DESIGN REVIEW TECHNICAL ADVISORY COMMITTEE MEETING

June 8, 2015

DESIGN REVIEW TECHNICAL ADVISORY COMMITTEE STAFF REPORT

Date: June 8, 2015
Applicant: William Knapp
Owner: Robert & Jitka Schaffer
Location: 102 16th Avenue SW
Request: Conditional Use & Façade Review
Date Application Received: April 30, 2015

NORTH
SITE DEVELOPMENT PLAN
1" = 20'-0"

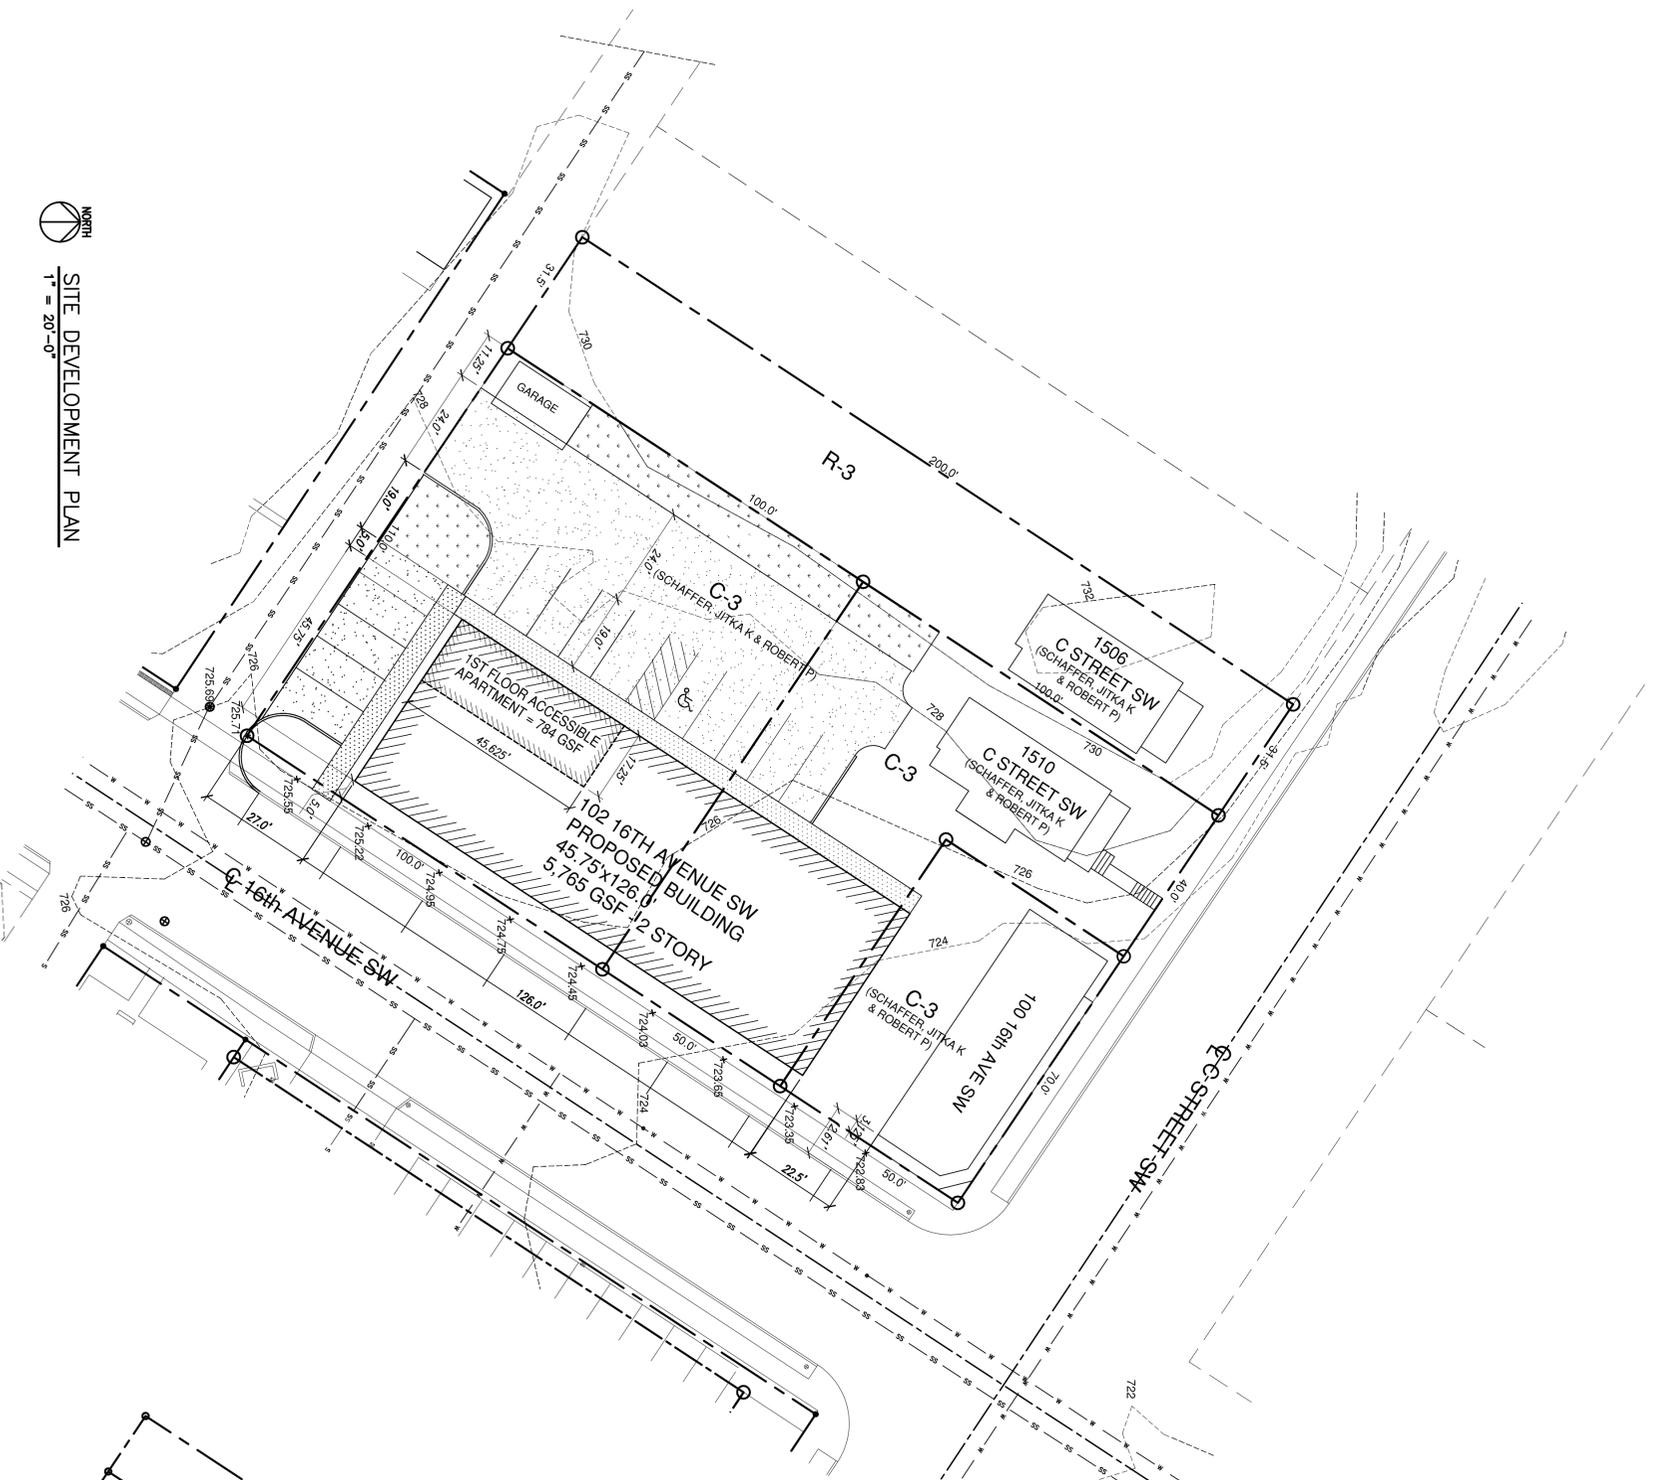
- Center building is out of context with the historic district
- Consider using a material other than brick underneath windows
- Consider having a consistent datum line for the windows
- Consider installing bollards near the garage
- Use the same windows throughout the building
- Work with City staff on the use of other materials on the backside of the building to add visual interest
